# A D D E N D U M N O . 1

**ATHLETIC FACILITIES RENOVATION  
PROJECT**

**DERBY HIGH SCHOOL**

KBA #17015.00 | CITY PROJECT NO. COD-02 REBID

**4 HOME BLEACHERS ALTERNATES**  
 SCALE : 3/8"=1'-0"

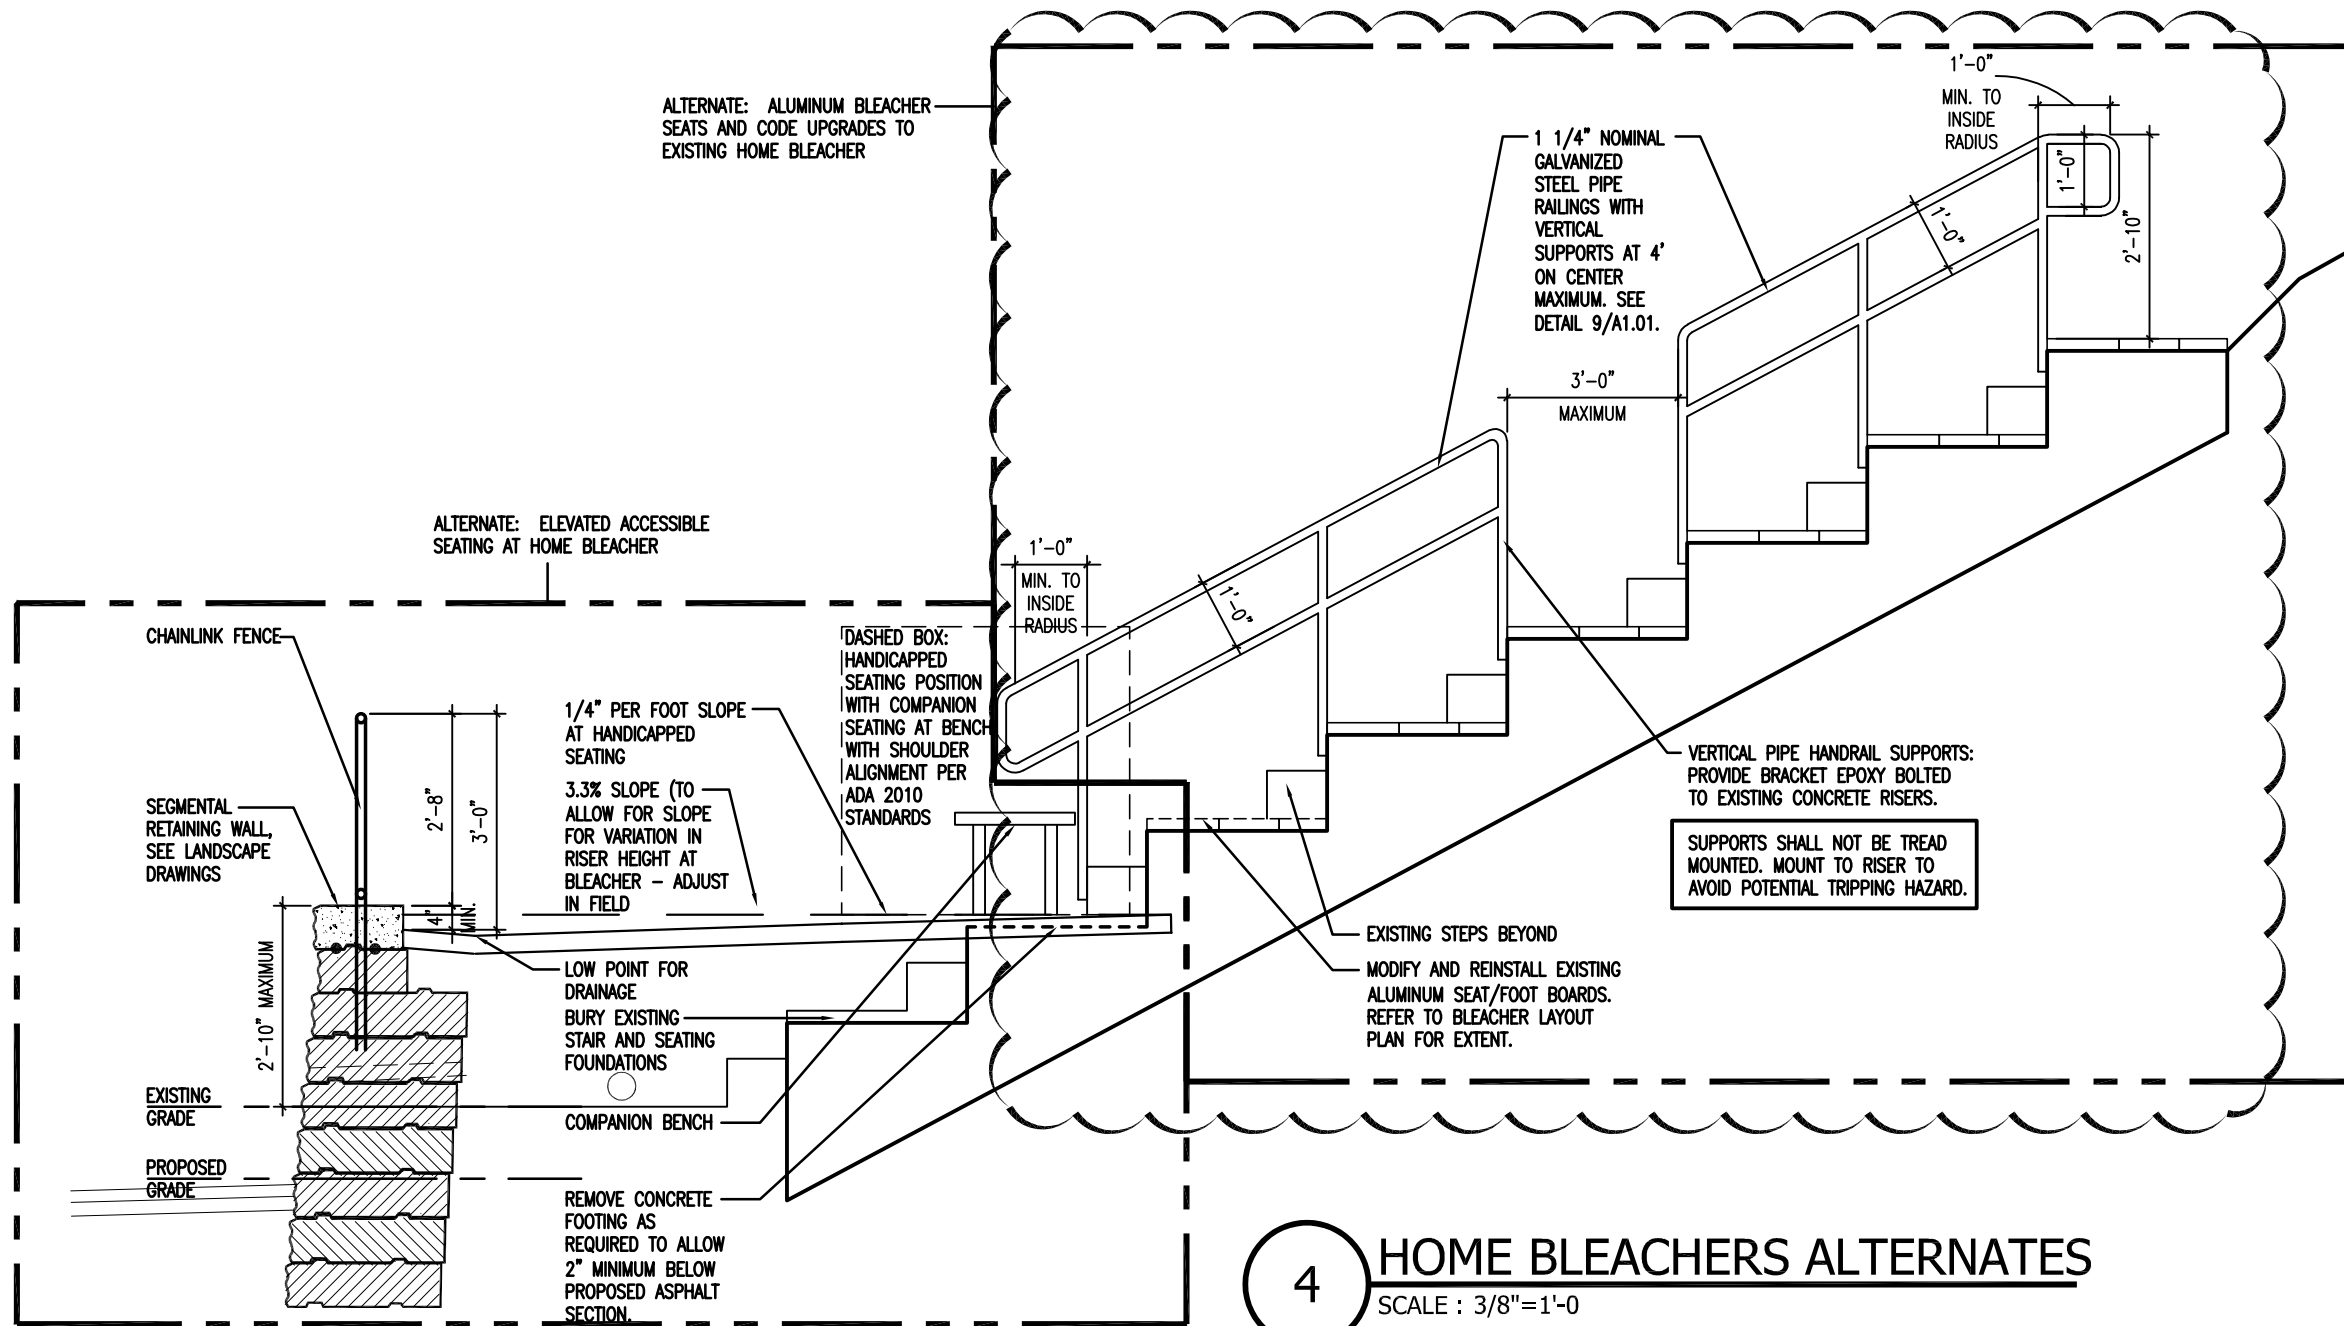
**A1.01 BLEACHER DEMOLITION PLAN, LAYOUT & SECTIONS**

Revise Section 4- Home Bleacher Alternates. See SKA-1.01.

**1 PRESS BOX FLOOR PLAN**  
SCALE : NOT TO SCALE

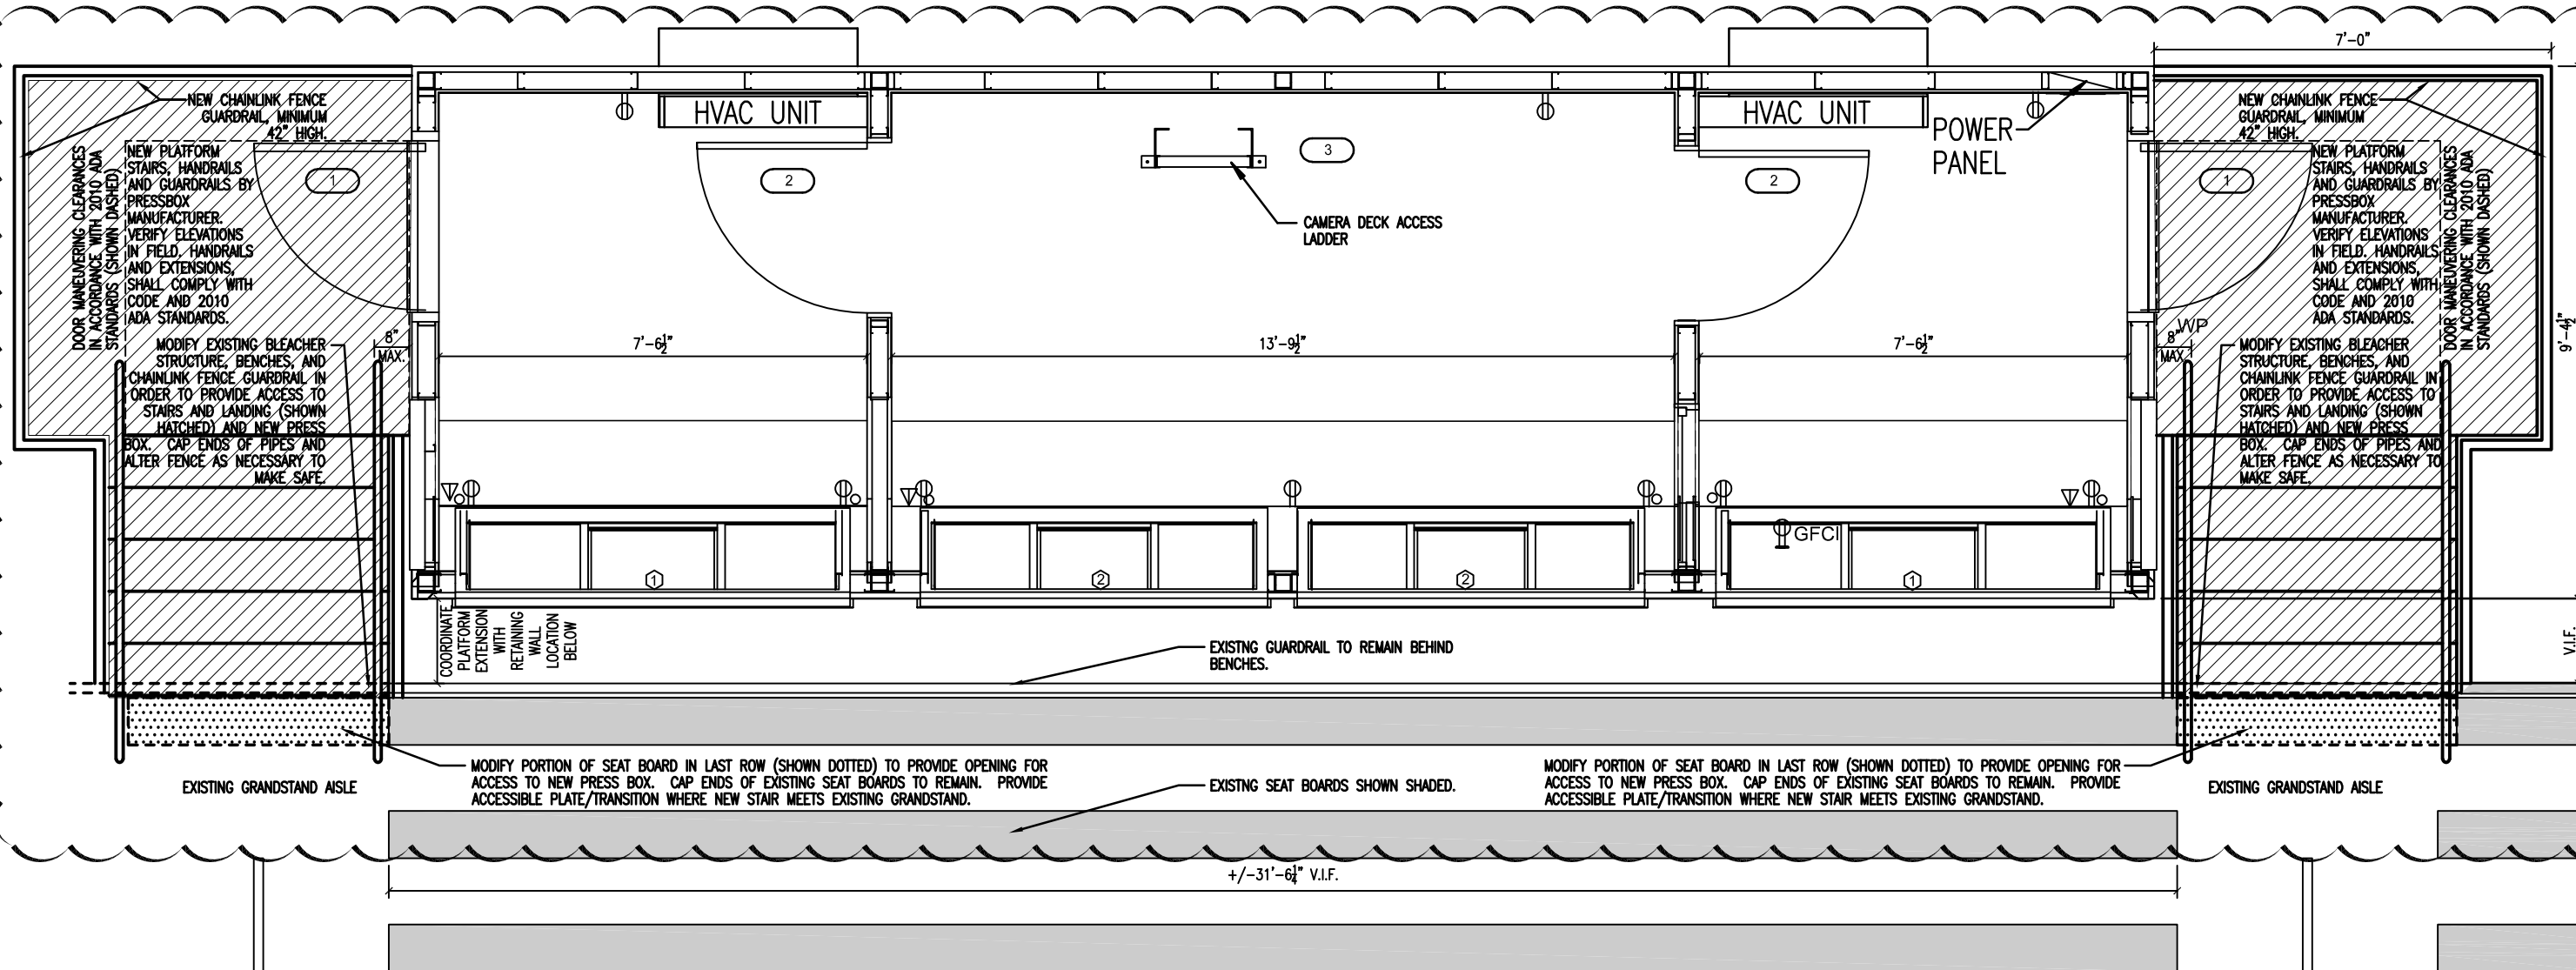
**A1.02 PRESS BOX PLANS, ELEVATION, SECTIONS & DETAILS**

Revise 1- Press Box Floor Plan. See SKA-1.02.
